VOLUME 2 OF 2 - ZONING

Summary of Comments on P:\Projects\1216-00\BIM\Revit \Families\TITLEBLOCKS\EXTELL Proposal_atwalj.pdf

Summary of Comments on AAI-TWR-ARCHITECTURE-CANTILEVER_namrudl.rvt

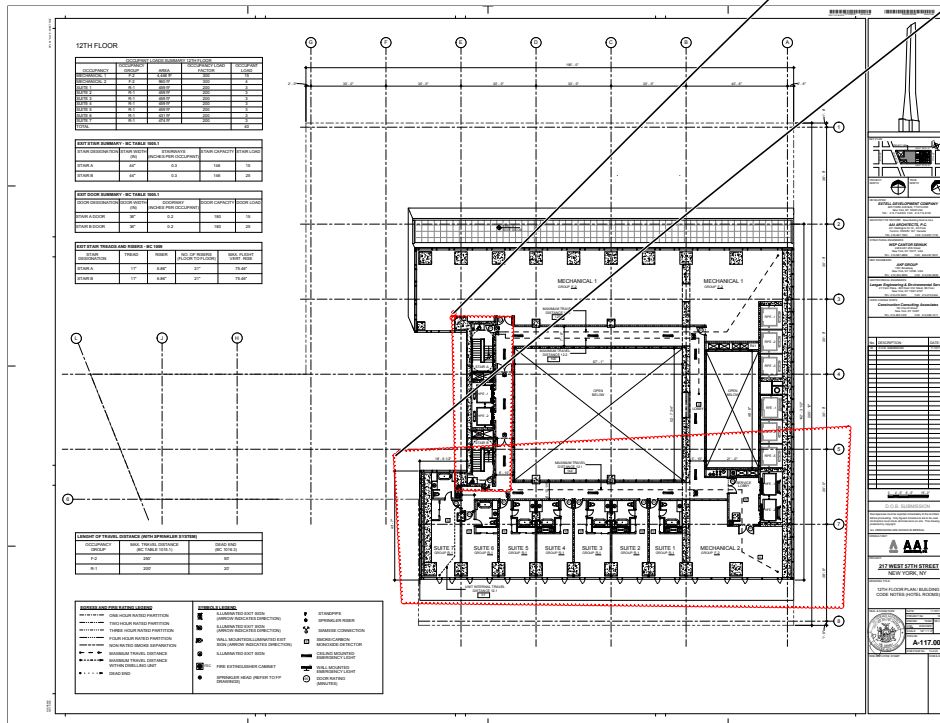
Group R-1 occupancies shall be provided with accessible features in accordance with Sections 1107.6.1.1 through 1107.6.1.3.

Show all grab-bars including vertical as per P102.8.3.1, (TYP)

Provide note within each accessible unit: unit or sleeping unit shall comply with the 2008 code and Chapter 1 through Chapter 10 of ICC A117.1.

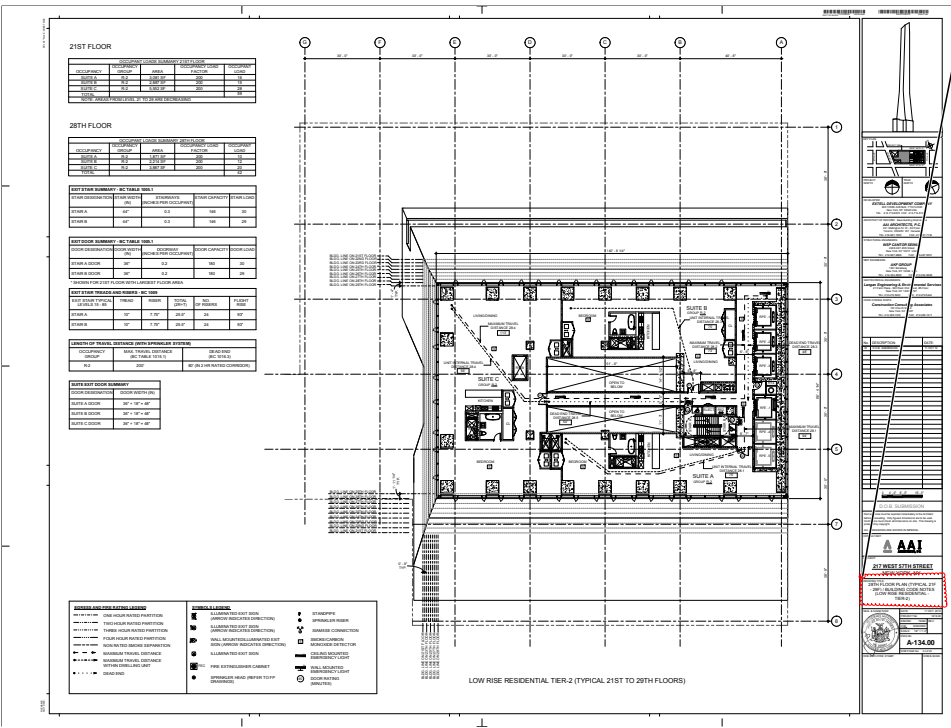
Author: dtitus Subject: Polygon Date: 1/7/2013 9:31:18 AM
The common path of egress travel shall not exceed 125 feet as per BC 1013.3. The maximum length of exit access travel, measured from the most remote point within a story/space to the entrance to an exit along the natural and unobstructed path of egress travel, shall not exceed the distances given in BC Table 1015.1.

Author: dtitus Subject: Polygon Date: 1/7/2013 9:30:14 AM
BC 908.7.1.2 Provide notes to indicate compliance for carbon monoxide detectors.
Indicate location of smoke/ carbon monoxide detectors. (TYP.)

Author: dtitus Subject: Polygon Date: 1/4/2013 10:06:27 AM
Provide refuse chute details: [2 hr fr walls & roof] and compliance with BC 1213.3 and BC 707.13
Refuse storage room to comply with BC 1213.1
Provide proper enclosure and details
Provide UL # for system or fire hopper doors
Compliance with BC 1101.2;

Author: dtitus Subject: Polygon Date: 1/4/2013 10:41:39 AM
Provide note describing stairway door operation and stairway communications system as per BC 403.12
Provide note describing smoke proof exit enclosures for compliance with BC 403.13.
Provide note describing impact-resistant stairs enclosures as per BC 403.15
Provide exit lighting and directional signs (lighting) & (egress) as per BC 1006, BC 1011, BC 1026 (both EG and Construction plans)

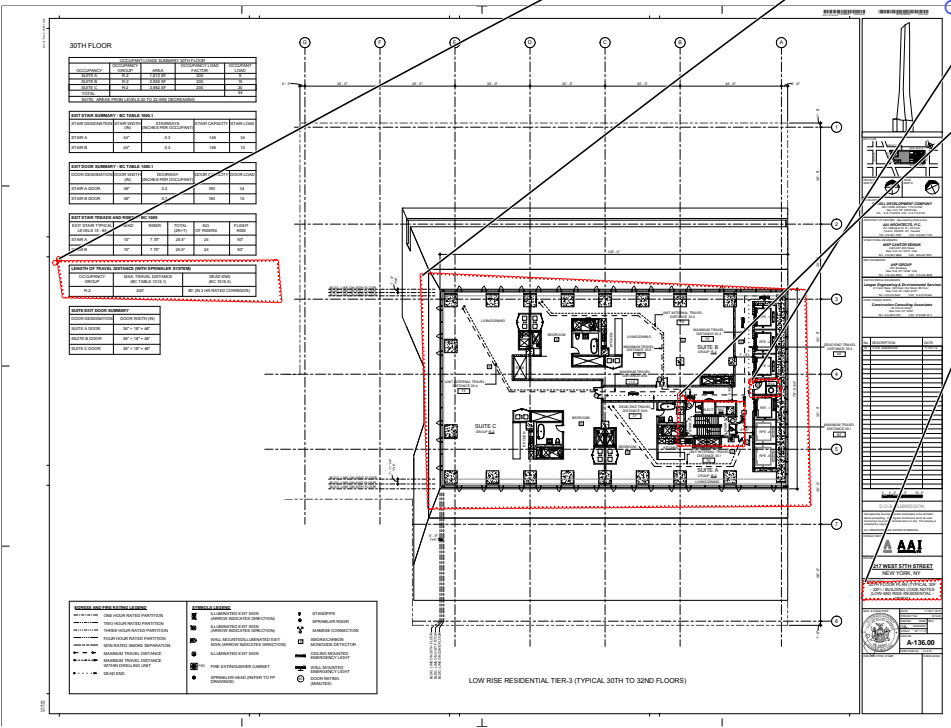
Author: dtitus Subject: Polygon Date: 1/4/2013 10:05:14 AM
Please indicate as Typ. 30-32nd Floor Plans

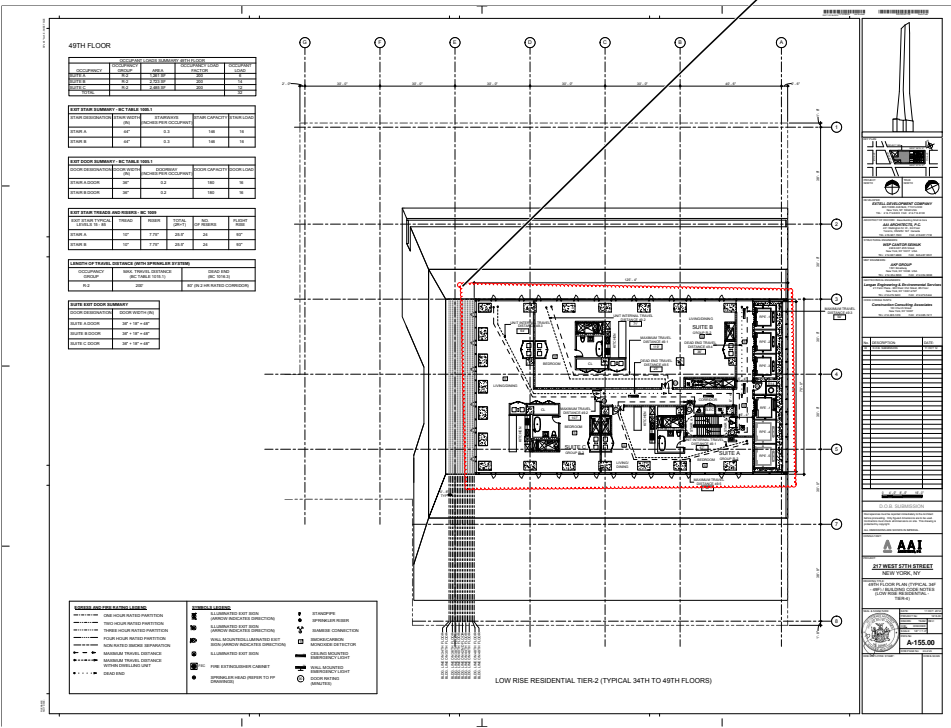
BC 1101.1, 1101.2, and
ICC/ANSI A117.1-2003 Verify compliance with accessibility as per BC 1101
Primary access- 1105
Doors & maneuvering clearances-1107.2.1
Residential bathrooms – 1107/ Appendix P
Residential kitchens – 1107.
Show all grab-bars including vertical as per P102.8.3.1,
Walk-in closets
Access to W/D within units
TYP. all R-2 floors

Provide fire protection of openings in exterior walls (BC 704.8, BC 705.8, BC 715.4).

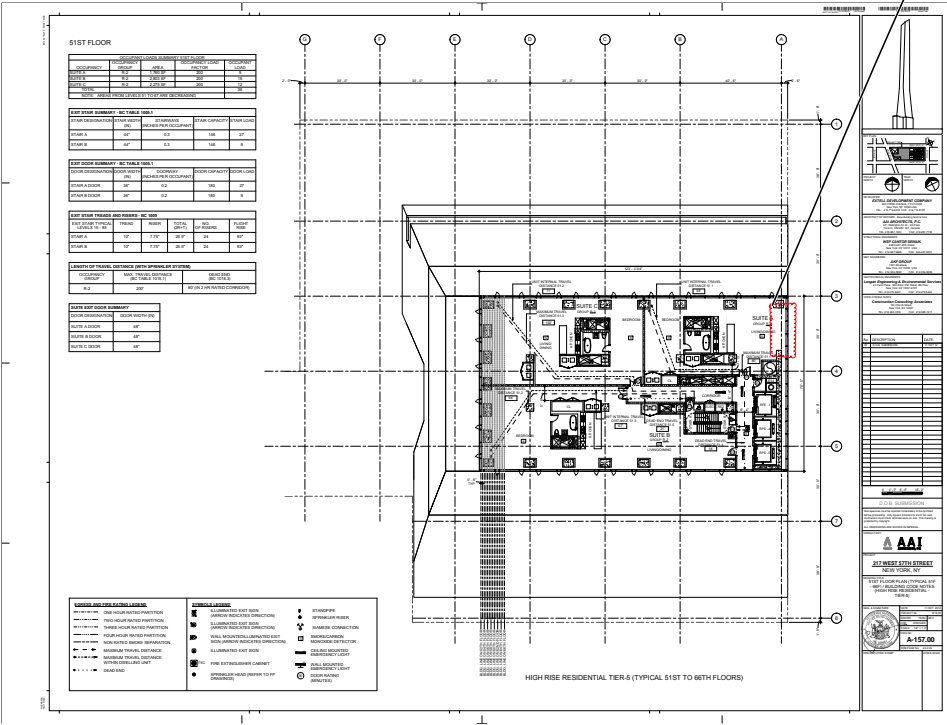
note required on elevation dwg. to indicate
1 hr rated wall.

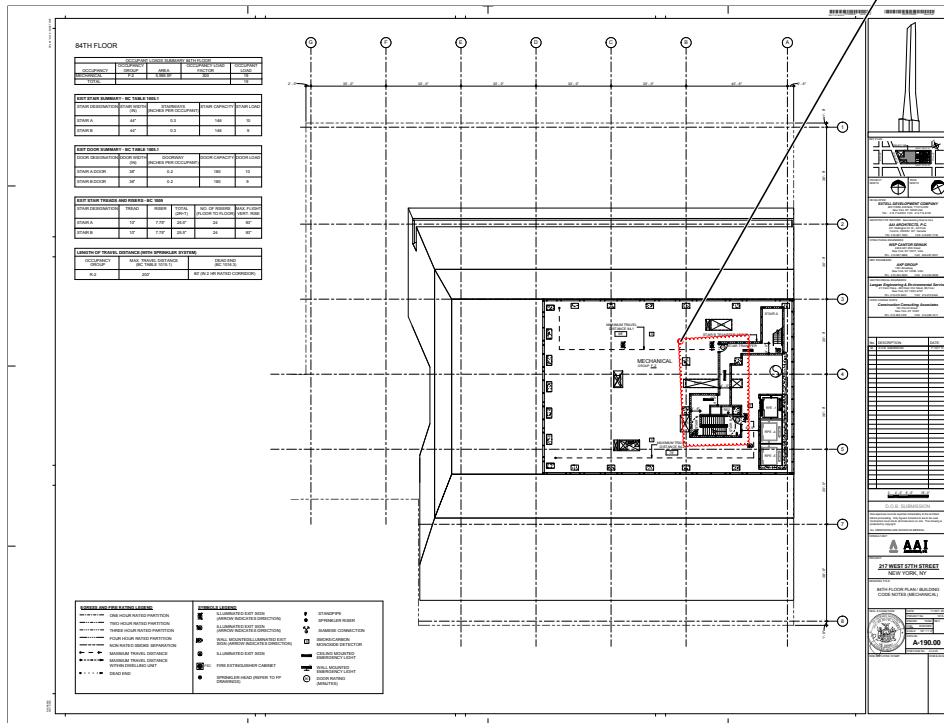
Author: dtitus Subject: Polygon Date: 1/4/2013 10:08:37 AM
A-occupancy

BC 403.11.1 Emergency power systems for *assembly occupancy*

4. Electrically powered fire pumps, unless electrical power to the motor is taken ahead of the main from the street side of the service switch.

Author: dtitus Subject: Polygon Date: 1/2/2013 11:59:00 AM
All interior stairs must lead to the roof as per BC 1009.12

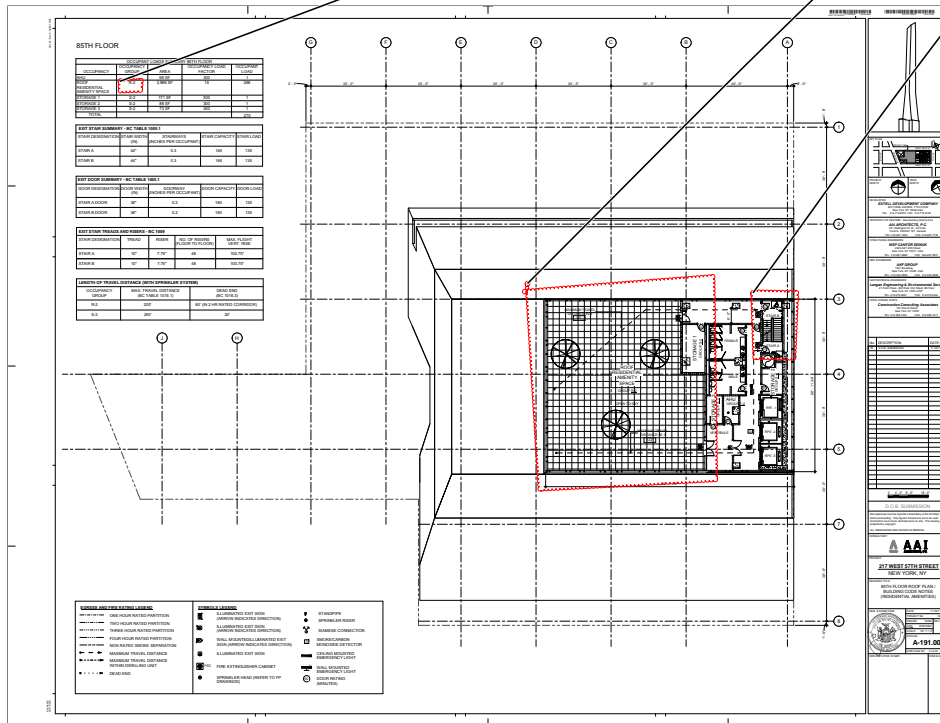
Shall the roof be considered as an additional story? Provide calculation for area of roof structures as per BC 504.3.

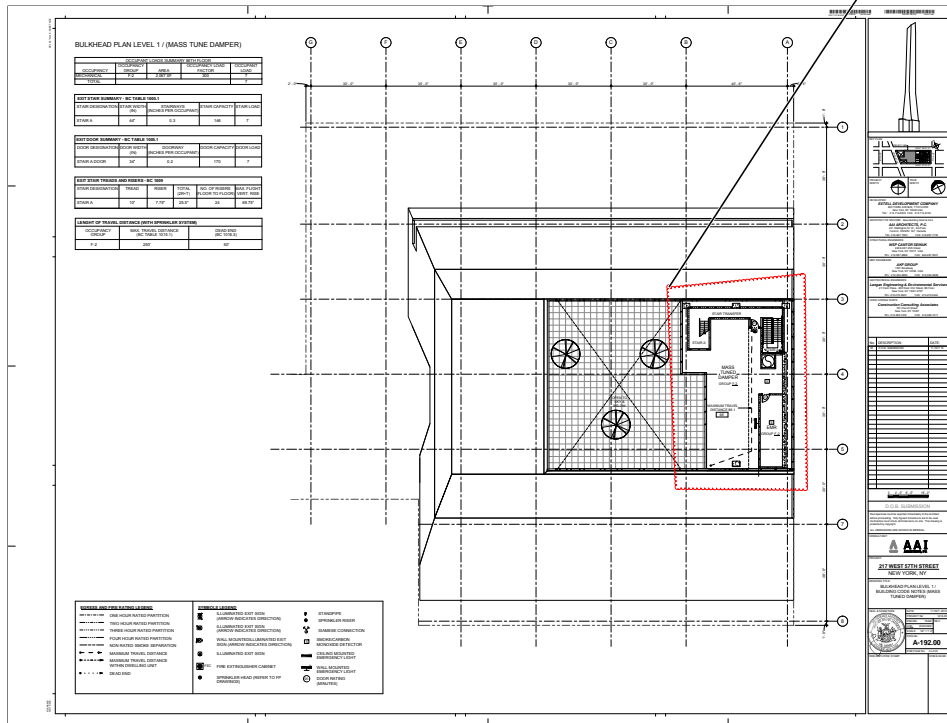
Show compliance with the requirements for elevator clearances (top & bottom) and runbys for cars and counterweight.

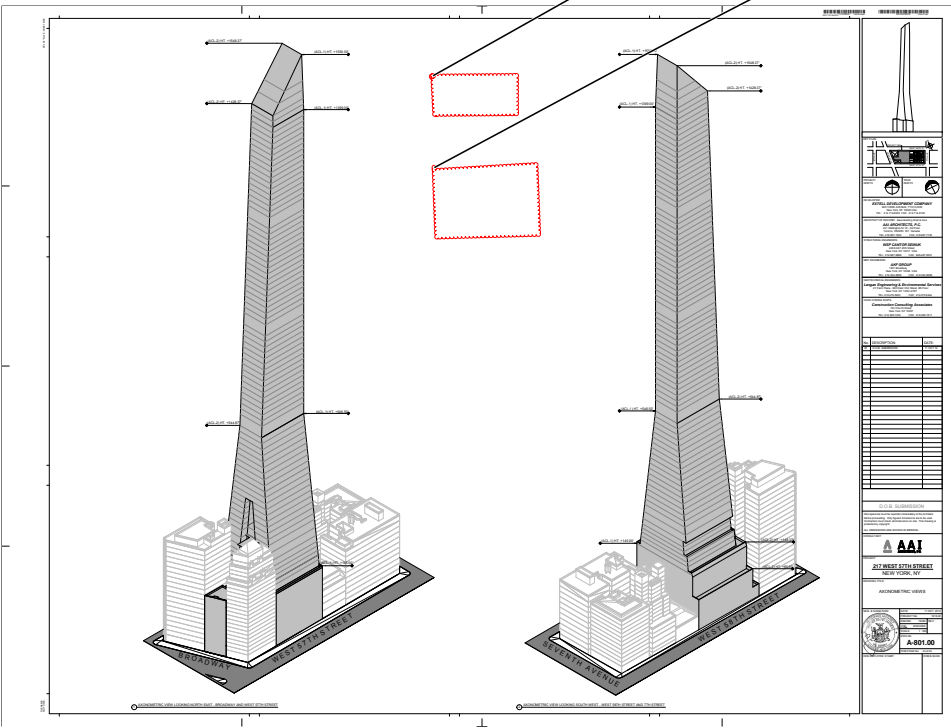
Provide all schedules windows, doors (indicate FPSC on all fire rated doors) etc.

Provide structural peer review report as per BC 1627.

Provide building elements, exterior walls of non-combustible construction with fire-resistance ratings for Type I-B construction (BC 602.1, BC 602.2).

Summary of Comments on FP-401.00

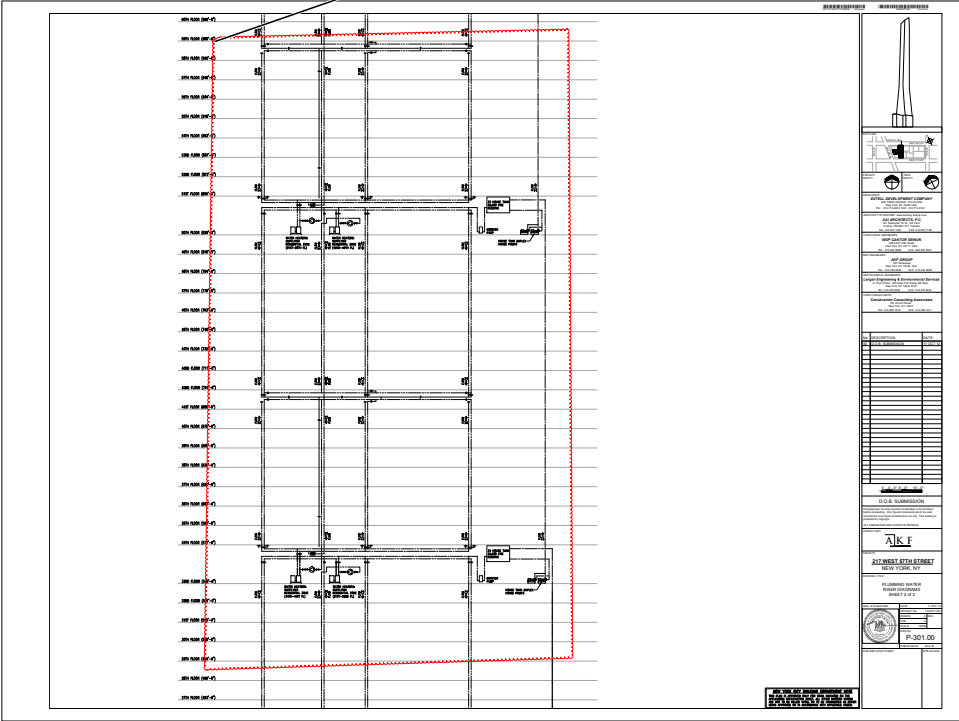
Author: dtitus Subject: Polygon Date: 1/8/2013 9:12:55 AM
Please provide a complete water and gas riser diagram.

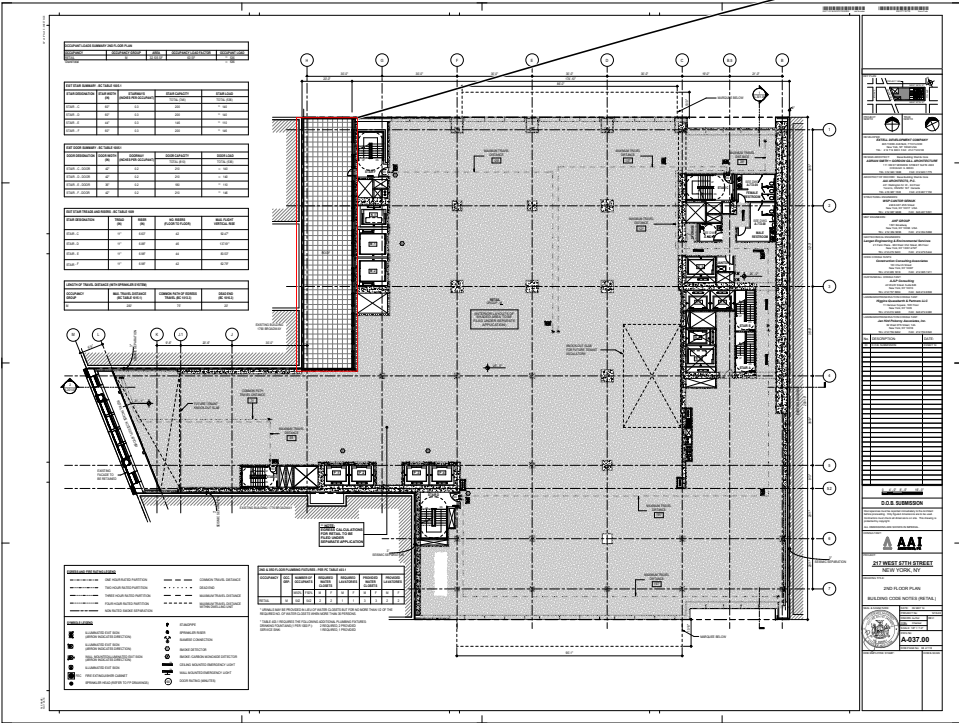
Author: dtitus Subject: Rectangle Date: 10/7/2014 7:38:16 AM
Provide net area of space and number of persons to be accommodated based on (15) sq. ft./person as per table 1004.1.2 BC
Provide the required number of exits per space, per maximum occupant load as per Table 1014.1.
Provide exit lighting and directional signs (lighting) & (egress) as per BC 1006, BC 1011, BC 1026 (both EG and Construction plans)

Provide net area of space and number of persons to be accommodated based on (15) sq. ft./person as per table 1004.1.2 BC.

Provide exit lighting and directional signs (lighting) & (egress) as per ~~BC 1006~~, BC 1011, BC 1026 (both EG and Construction plans)

roof no occ. 11-18-14

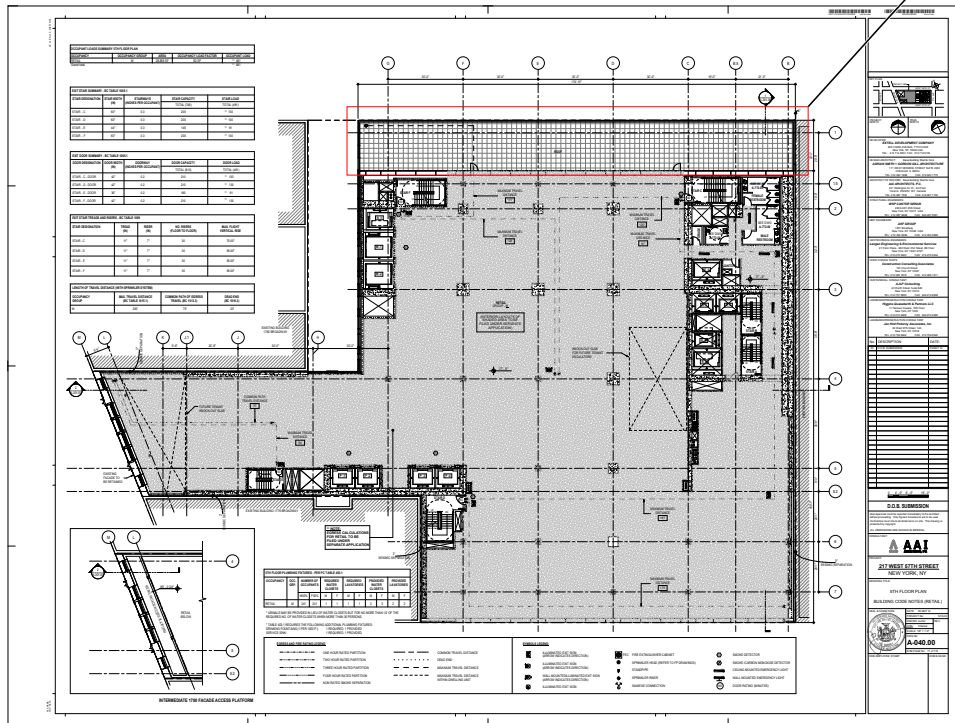
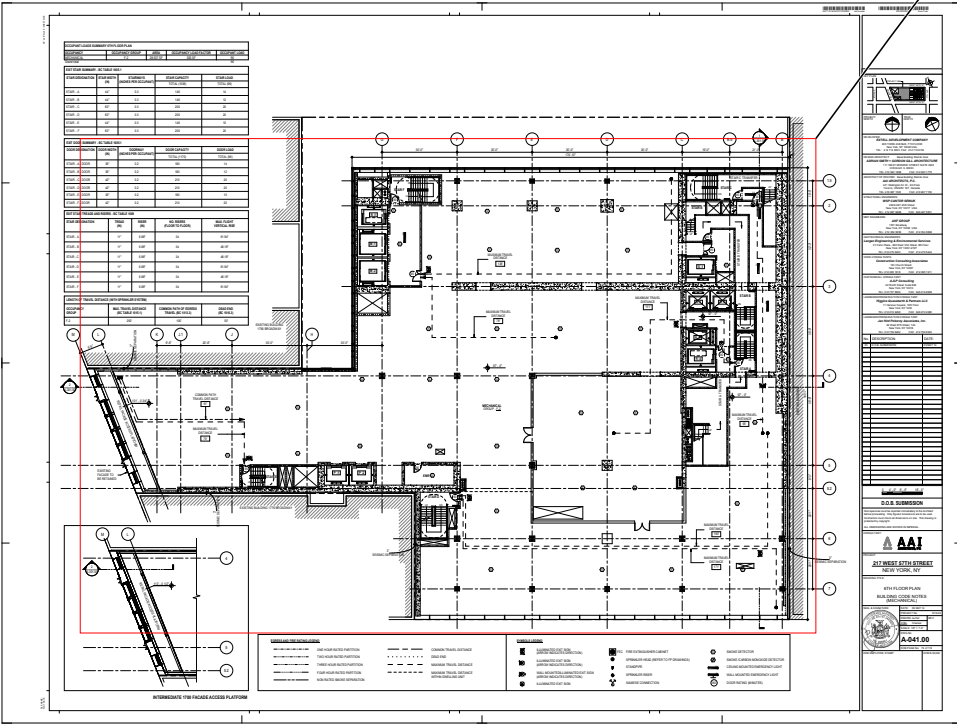
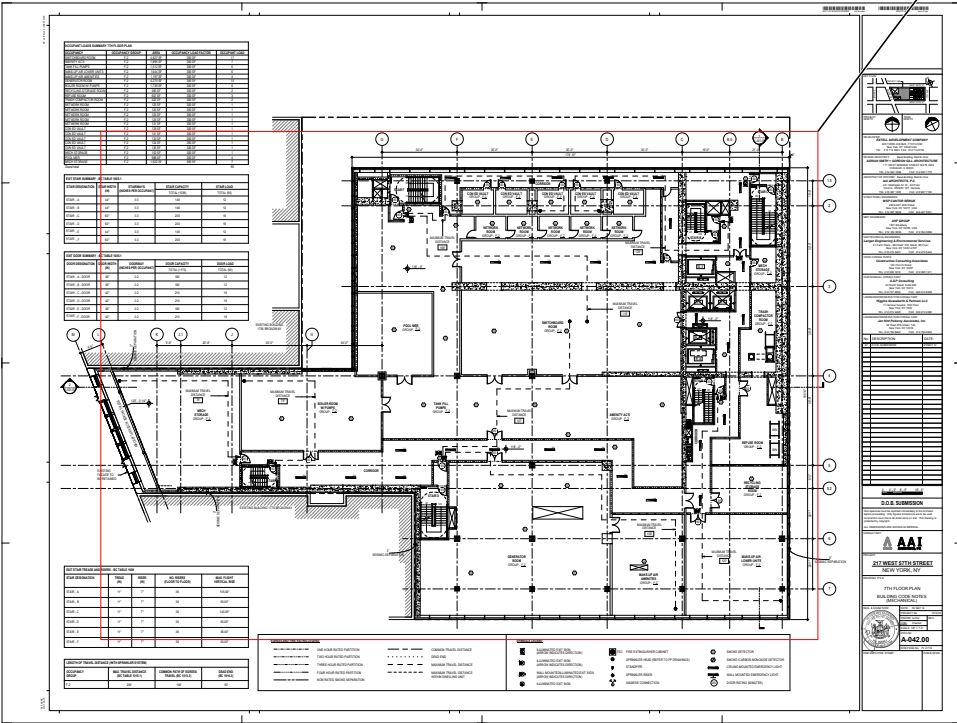
Author: dtitus Subject: Rectangle Date: 10/7/2014 8:25:25 AM
TABLE 403.1 Provide table for plumbing fixtures to comply with table. 403.1. Provide calculations within each space, 11-18-14

open Provide the required number of exits per space, per maximum occupant load as per Table 1014.1.

Provide the required number of exits per space, per maximum occupant load as per Table 1014.1. 11-18-14

A-3 Author: dtitus Subject: Rectangle Date: 10/7/2014 8:03:54 AM
A-2 occ.

Author: dtitus Subject: Rectangle Date: 10/7/2014 8:03:24 AM
R-2 occ. 11-18-14
